Report to the Future Melbourne (Planning) Committee

Agenda item 6.1

**Planning Permit Application: TP-2018-799
205-211 Roden Street and 218-228 Stanley Street, West Melbourne**

PLANNING PERMIT APPLICATION DELEGATE REPORT

Figure 15: Roden Street Elevation. Red line showing extent of refused building envelop (Source: Point Architects Pty Ltd)

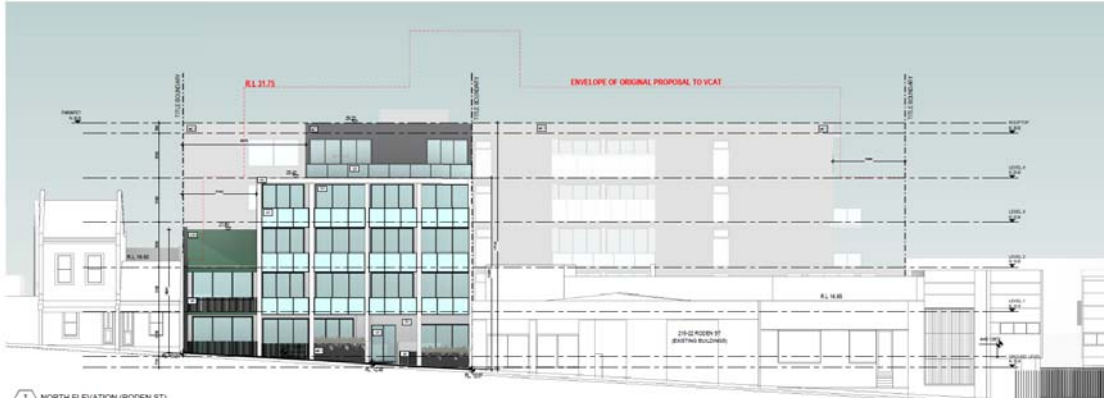
In summary the application addresses the matters raised in the VCAT order by:

- Reducing the height of the building by one level and deleting the roof deck (See figures 10 and 11)
- Retention of the front 11.3 metres of the contributory heritage at 210-212 Stanley Street
- Splitting the building into two built forms facing the two street frontages.
- Removal of a second basement
- Increasing the setback on Levels 2-3 to the west from being on the boundary to being setback 3 metres.
- Increasing the extent of brickwork to Stanley Street
- Increasing the setback to the east adjoining 203 Stanley Street from 4.61 metres to 5.16 metres and introduction of a pitched roof form

Figure 20: Recent approved Developments under DDO29 (Source: Development Activity Model)

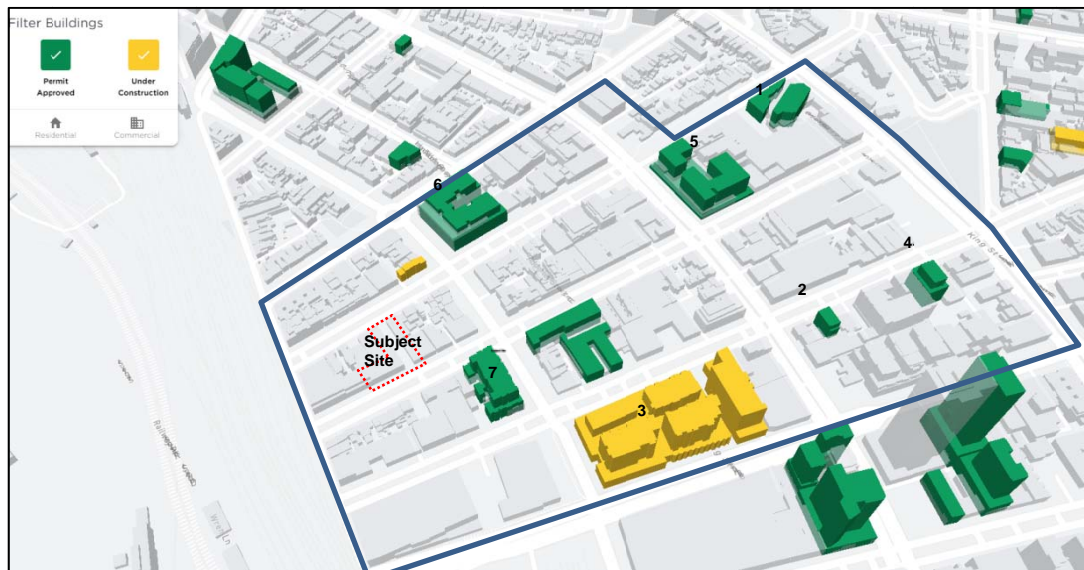
The proposal includes variable building heights and exceeds the discretionary four-storey height control of DD029 by two storeys.
